ARCHITECTURAL ADVISORY COMMITTEE MEMORANDUM

SUBJECT: REQUEST BY PALO FIERRO ESTATES FOR MINOR ARCHITECTURAL REVIEW APPROVAL TO CONVERT 3,600 SQUARE FEET OF THE EXISTING LANDSCAPE AND INSTALL LANDSCAPE LIGHTING ON THE EAST LA VERNE WAY FRONTAGE AT 2082 LAGARTO WAY, ZONE RMHP, SECTION 26 (CASE NO. 3.700 MAA). (NK)

3.700 MAA
 2082 Lagarto Way
 Palo Fierro Estates
 (APN: 511-171-035)

LANDSCAPE PLAN

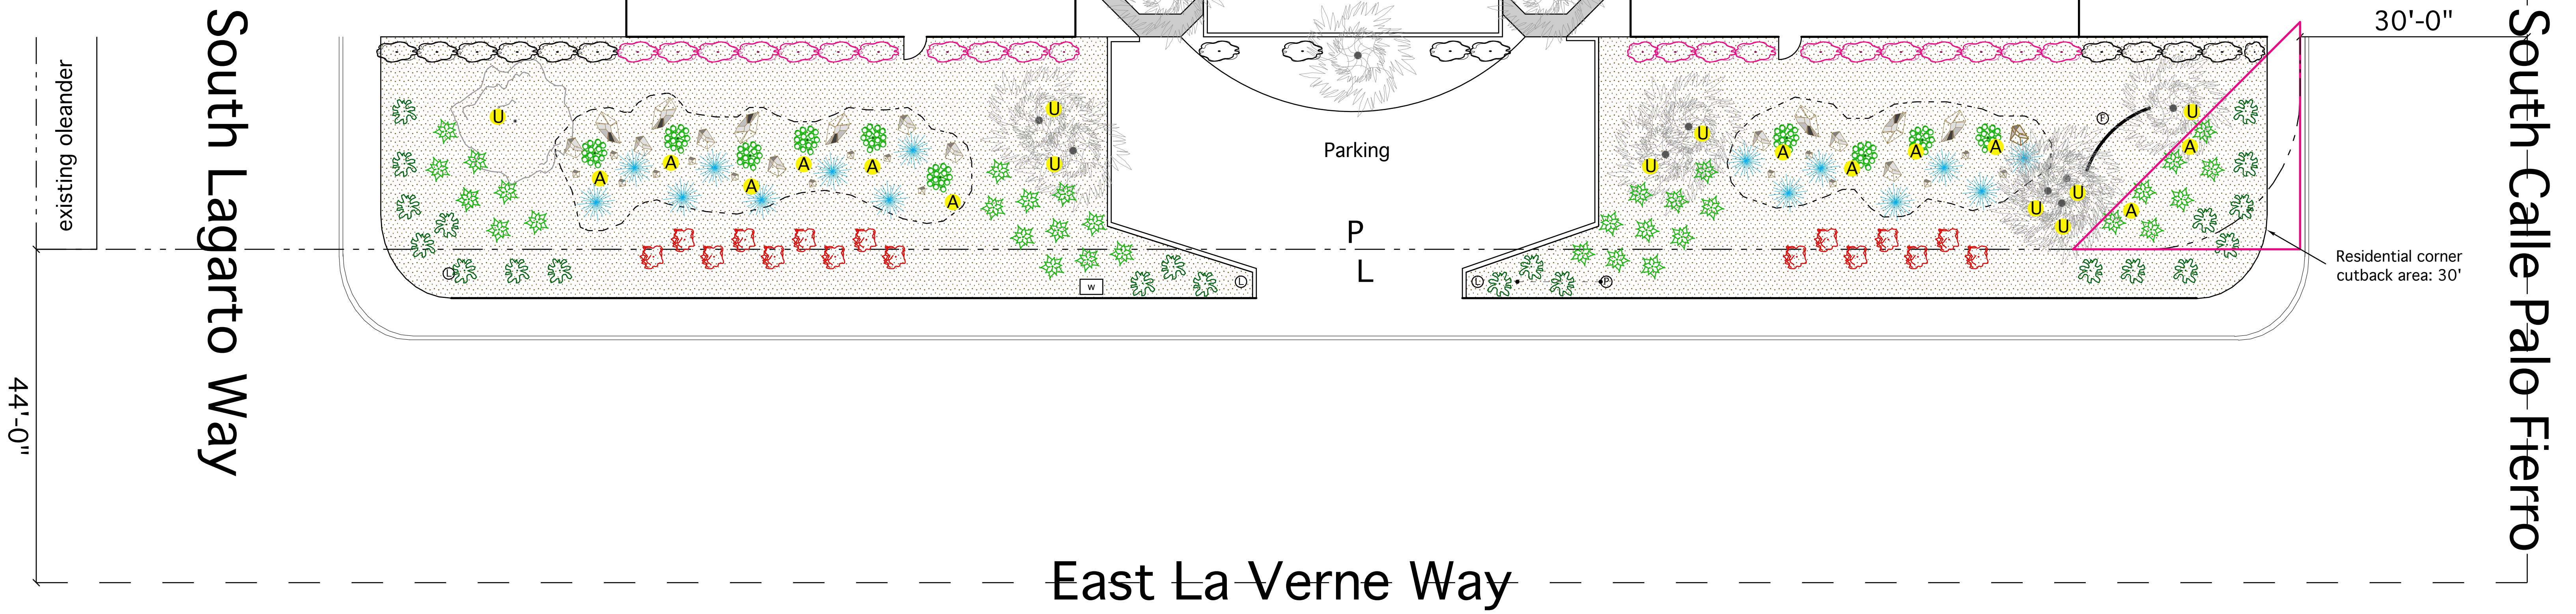
Table 1.1 Applicant’s Response to AAC Comments			
	AAC Comments	Applicant’s Response (Attachment #3)	Design Changes/Analysis
1	The visibility of the trash bins needs to be mitigated.	Planting tall hedges along the motor court walls is not contextually appropriate for the site.	No changes to address this comment.
2	Design Issues: (e.g. application of crushed rocks relative to plant material type, planting techniques such as layering and clustering, plant diversity, appropriateness of scale)	The quantity of plants and the amount and size of the boulders has been increased. The previously proposed Copper Canyon crushed rocks, Mexican Petunia, Gaura, and Angelita Daisy have been omitted from the revised plan. An increase in the plant size will be cost prohibitive.	The comparison of the previously submitted landscape plan and the revised plan shows the size of the boulders has not been changed. Small-scale perennials (e.g. Mexican Petunia, Gaura, and Angelita Daisy) have been omitted from the revised plan. The size and scale of the rest of the plant palette have not been increased, and the plant diversity is reduced due to the omission of the perennials. The landscape treatment on both sides of the motor court driveway and the corner of South Lagarto Way and East La Verne Way is incorporated better to the overall design compared to the original proposal. No changes to the clustering or layering technique is observed.

3	Inadequacy in the information presented on the Landscape plan (e.g. Lacking the existing buildings, walls, or trash bin storage area)	The revised plan includes the location of the existing walls, motor court, and front entry landscape.	The revised plan includes the additional information requested by the AAC.

Table 1.1 Applicant's Response to AAC Comments			
	AAC Comments	Applicant's Response (Attachment #3)	Design Changes/Analysis
4	Correlation between the architecture and the landscape is desirable.	The previously removed Bougainvillea hedges will be replaced.	The installation of Bougainvillea hedges along the south elevation of the buildings is proposed.

The revised plan depicts the location of the existing walls, doors, motor court, and front entry landscape. While the response letter (Attachment #3) states that the size and quantity of the boulders have been increased, the comparison of the original and revised plans shows no such changes. The revised plan does not address the visibility of the trash bins stored in the motor court, and the applicant notes that the installation of screening plant materials near the motor wall walls would be contextually inappropriate for the site. The project proposes to replace the previously removed Bougainvillea hedges. The installation of Copper Canyon crushed rocks and perennials (Mexican Petunia, Gaura, and Angelita Daisy), which was previously proposed on both sides of the motor court driveway, has been omitted from the proposal. No drastic changes to the previously proposed clustering or layering technique is shown on the revised plan, though the overall composition is improved by the changes proposed to the landscape treatment of the motor court driveway landscape.

The revised landscape plan does not fully address the design concerns presented by the AAC, particularly the appropriateness of scale in the proposed plants and boulders, the concealment of trash bins, and the overall composition. Staff finds that the size of the proposed boulders, particularly those ranging from 12 inches to 18 inches in size, are not compatible to the scale of Nightblooming Cereus, Mexican Fan Palms, or the width of the adjacent street (East La Verne Way) to function as an effective accent. Additionally, there is an excessive amount of spacing amongst Variegated Fountain Agave, Gopher Plant, and Crown of Thorns groupings, which altogether compromise the overall composition by weakening the balance between open and closed spaces. On the other hand, the removal of Copper Canyon crushed rocks and perennials from the motor court driveway entrance and the installation of Variegated Fountain Agave and Gopher Plant contributes to a more cohesive appearance compared to the previous submission. Although staff agrees that the installation of screening plant materials along the motor court walls for the sole purpose of concealing the trash bins may not be an appropriate design solution, the visibility of the trash bins can be mitigated by extending the proposed Bougainvillea hedges along the motor court walls to the point where the trash bins are located to make them blend into the surrounding landscape and be less conspicuous. Considering the fast-approaching DWA funding deadline for the project and the improvement shown for the motor court driveway entrance landscape, staff recommends the AAC approve the project subject to the staff recommendations stated in this report.

1. Reduce the spacing between individual Gopher Plant, Variegated Fountain Agave, Crown of Thorns (*Euphorbia milii*) plants to stress the differentiation of open and closed spaces to achieve stronger composition.
2. Include boulders that are larger in size and omit small boulders which range from 12 inches to 18 inches in size.
3. Extend the Bougainvillea hedges along the motor court walls to the point which extends beyond the trash bins to make them appear less conspicuous.

LANDSCAPE PLAN

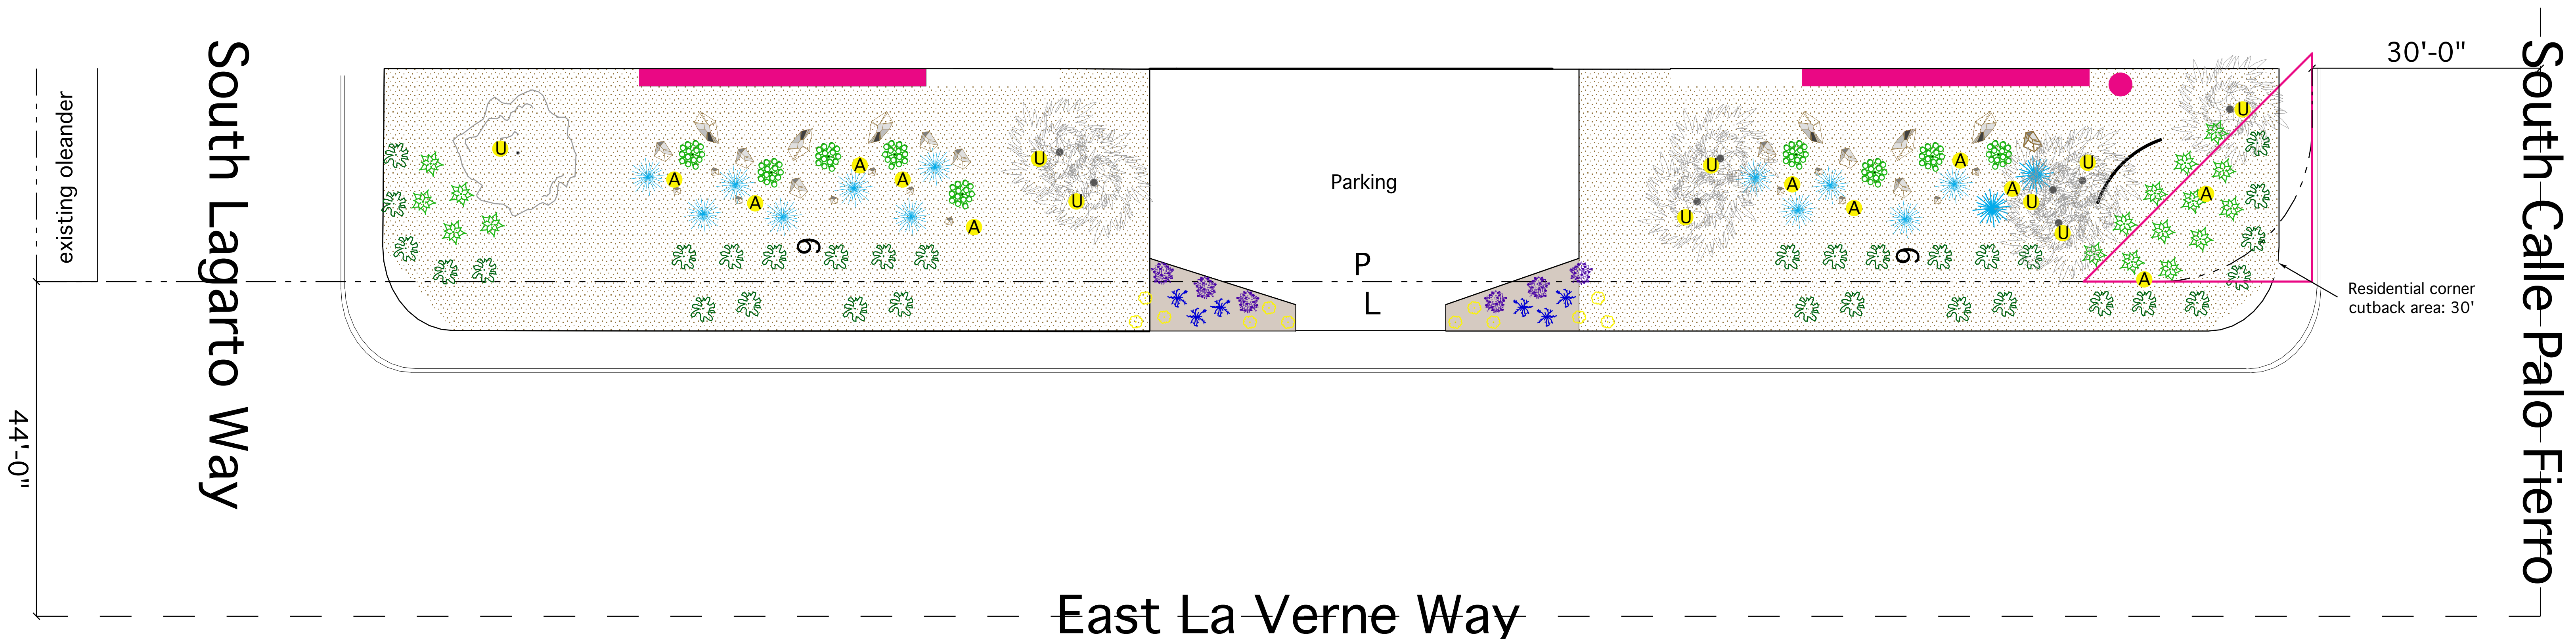
Member Lockyer commented that there are numerous items missing from the landscape plan, which includes the two (2) existing angled walls in the entrance area. He noted that there are trash bins stored in the area, and the proposed plant height is not tall enough to conceal the visibility of the bins. Member Lockyer added that the Mexican Fan Palms appear to be "broomsticks", and the area under the palms appears under-planted. Additionally, he stated that the proposal is incomplete as the submitted landscape plan is missing a lot of information, which included the existing buildings and walkways.

Member Poehlein stated that he agrees with Member Lockyer's comments. He said that removing taller shrubs on either side of the entrance walls will make the trash bins visible. Member Poehlein stated that there is a general lack of composition, and the

Member Lockyer stated that the submitted plan appears incomplete, including the information presented in the landscape plan, as well as the plant materials. He added that the plan does not show the existing buildings, walls, or trash bin storage area, and the landscape needs to be integrated better. Member Lockyer stated that he does not see any correlation between the architecture and the landscape and did not agree that the project will improve the aesthetics as submitted. If the project were to be treated as a turf replacement project, it requires a certain amount of plant coverage. The health of the existing Mexican Fan Palms is questionable, and the canopy cannot be counted towards the plant coverage. Also, the 707-square-foot plant coverage of the Olive tree seems excessive and may be inaccurate.

Member Doczi stated that he is able to see the pattern the designer tried to create as shown in the placement of taller plant materials in the back. While the use of numerous plant materials may not be necessary, the materials to be used need to be larger specimen-size. Member Doczi recommended the applicant use the buildings as a backdrop and come up with a design that complements the architecture. The size of the materials does not have the strength to create strong design as proposed. The landscape design can be simple, but it must be strong design, and the use of larger materials may be able to help achieve the goal.

Member Thompson stated that he agrees with the comments provided by the other AAC members. The size of the boulders is small, and they appear more like larger rocks. The rectangular landscape treatment of the driveway entrance stands out, and it is not cohesive.

Vice Chair Rotman stated that he agrees with the comments provided by other members. The Bougainvillea has been removed, and the site is a blank slate. Layering and plant variety, which could fulfill the site's potential is desired, and the boulders need to be wider and more diverse in size. Plant placement is too regular, and no clustering is observed. Vice Chair Rotman added that the plan needs to be reevaluated and resubmitted for further review. He asked the applicant for the deadline to complete the project to meet the DWA turf removal program requirements.

Rotman, seconded by Doczi to deny the application as submitted. Staff to work with the applicant so that the applicant can apply the AAC comments to their revised landscape plan. Although the motor court area is not a part of the project area, the parking area and the screening of the trash bins should be a part of the overall plan.
